Device **C504-2E**
Marking/Step **Step CB**
Package **P-MQFP-44**

This Errata Sheet describes the deviations from the current user documentation. The module oriented classification and numbering system uses an ascending sequence over several derivatives, including already solved deviations. So gaps inside this enumeration can occur.

1 History List/Change Summary

Figure 1 Reset Circuitries

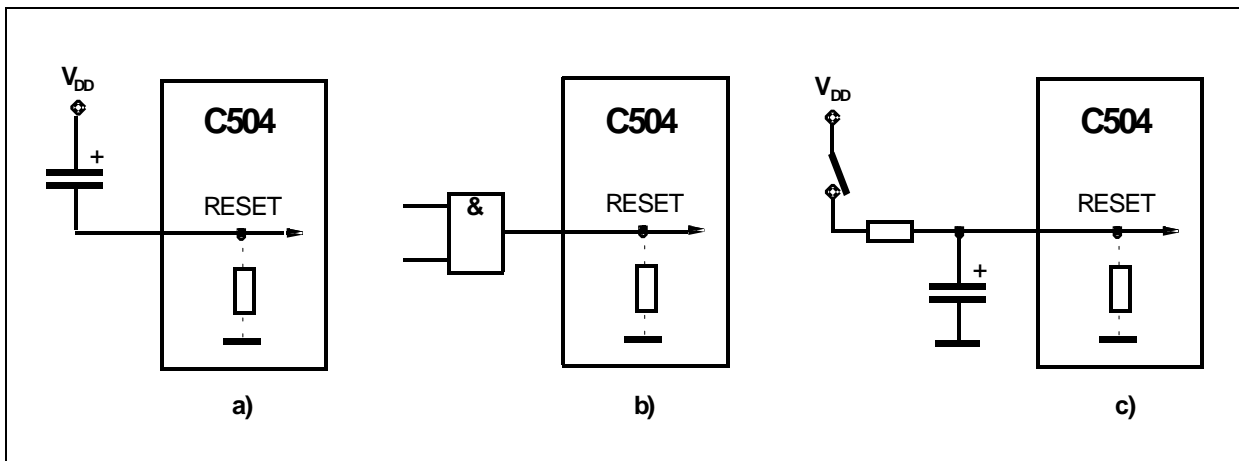
RST.1: Figure in User’s Manual and Data Sheet regarding the Reset Circuitries is incorrect

Figure 5-1 in User’s Manual and Figure 6 in Data Sheet show incorrectly that the RESET pin has an internal pullup resistor connected to the V_{DD} . Instead, at the RESET pin, an internal pulldown resistor is connected to the V_{SS} . The correct implementation is illustrated in [Figure 1](#).

This correction will be updated to the future versions of the User’s Manual and Data Sheet.
